HARDWARE PATCH for Zemmix Neo, SX-1, SM-X and related machines (update 2020.04.06)

2020.08.19 Hardware Patch for OCM machines “aka BUSDIR_n patch”

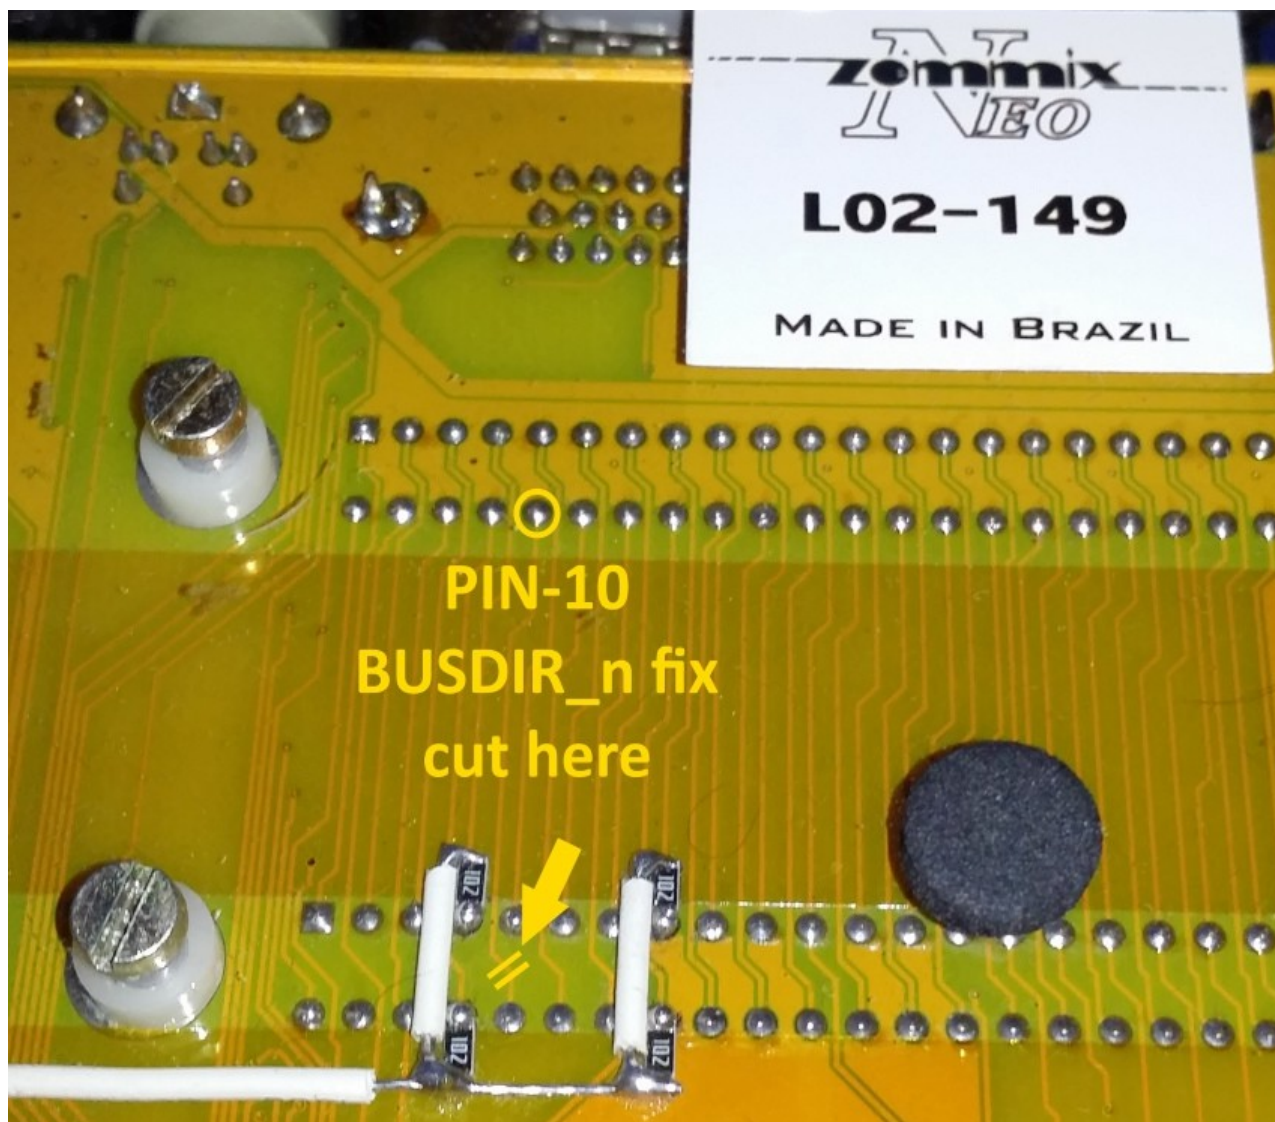
- In OCM machines we have a short circuit between pin-10 (BUSDIR_n) of the two external slots that continues towards the FPGA. This type of connection confuses some cartridges.
- While the Panasonic FS-A1ST and Canon V-20 service manuals confirmed that the BUSDIR signal is not used.

- Pin-10 (BUSDIR_n) of the external slots must be isolated.

- Method 1 - Cut the track that connects pin-10 of Slot-1 and Slot-2 leaving unchanged the connection to the FPGA already internally isolated by the firmware.
- Method 2 - Desolder pin-10 of slot-2 from the PCB and insulate it with the sheath of an electric wire and a drop of hot glue.
- Method 3 - Place non conducting tape over pin 10 of those cartridges that are not working properly, such as MoonSound and Darky.

2020.10.16 Hardware patch for Zemmix Neo BR machines (aka +5V line stability fix)

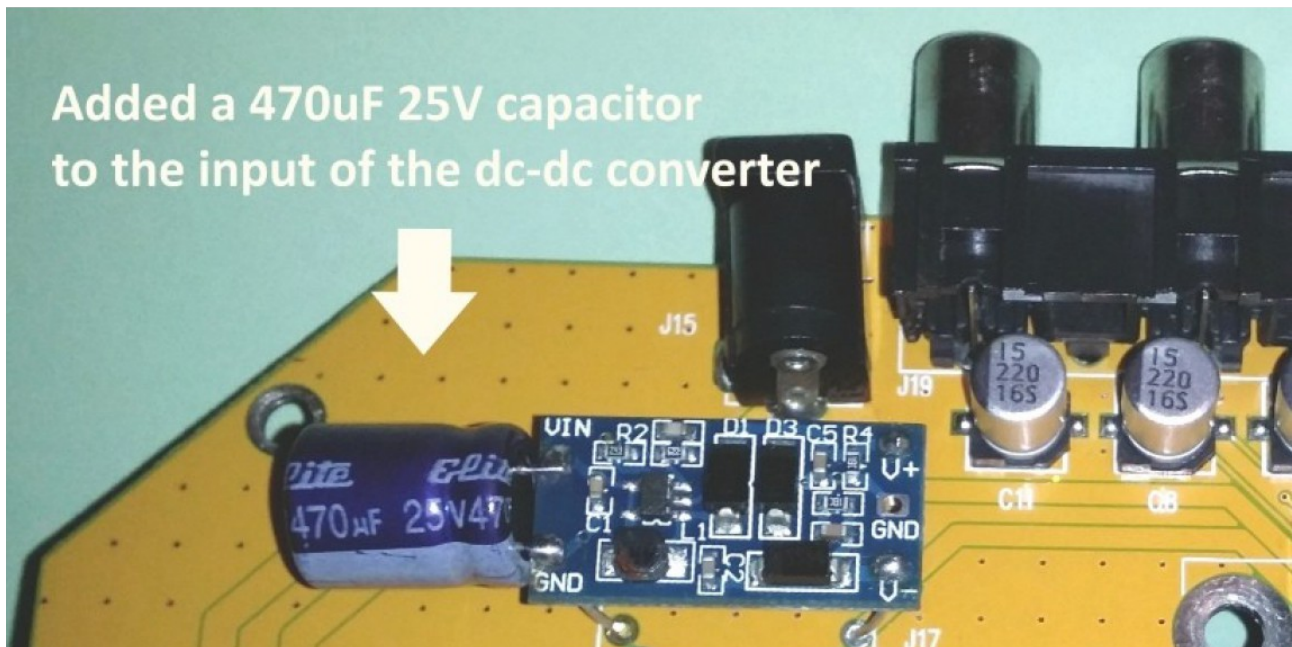
Based on the wiring diagram of the original 1chipMSX machine, I have implemented this new hardware patch for Zemmix Neo Brazilian which allows to stabilize the +5V input line. This patch can for example remove some annoying video interference on the output of GFX9000 and other similar cartridges. Please be informed that the problem is currently only present on Zemmix Neo Brazilian and not with Zemmix Neo Korean, but this fix can still be used if your hardware is unstable.

(aka PS/2 keyboard compatibility fix) [Revision 2]

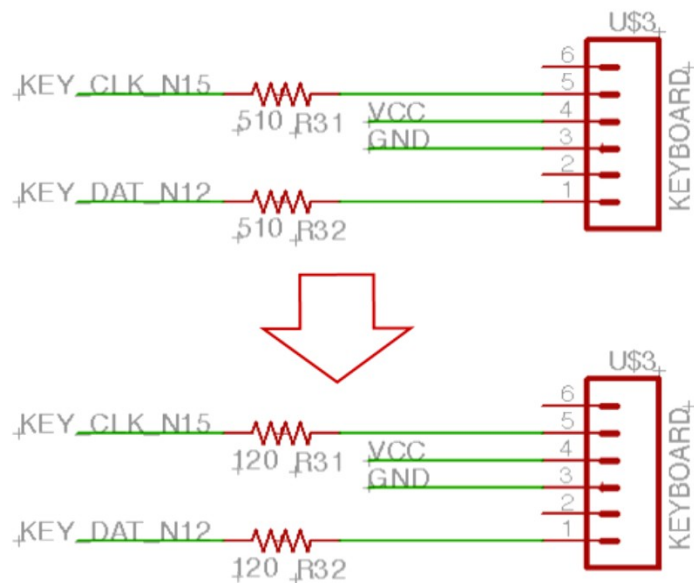
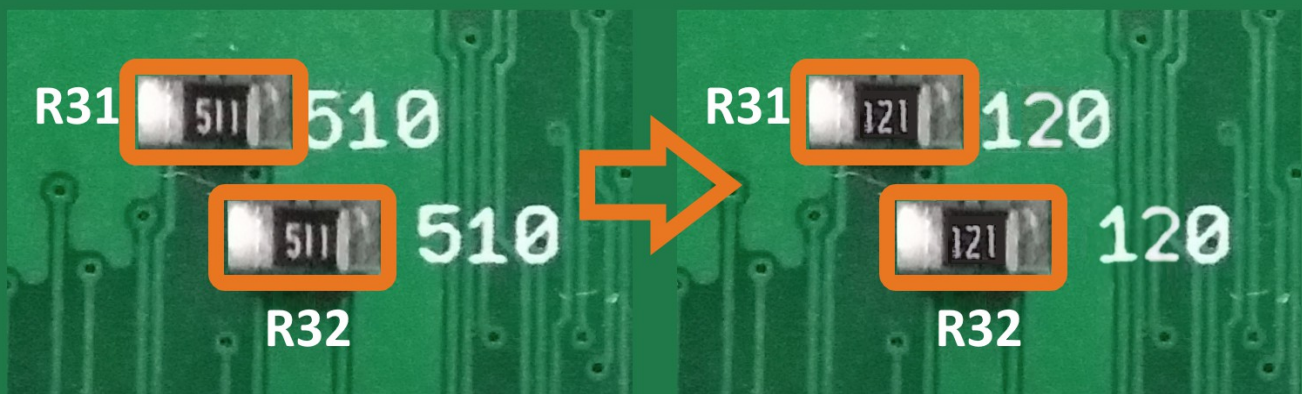
This is an optional fix. If your keyboard is NOT working properly you can apply this hardware patch or purchase another keyboard.

How to do it: replace the resistors
R31 and R32 with a value between 120 Ω and 390 Ω .
A value of 120 Ω is recommended to ensure maximum compatibility.
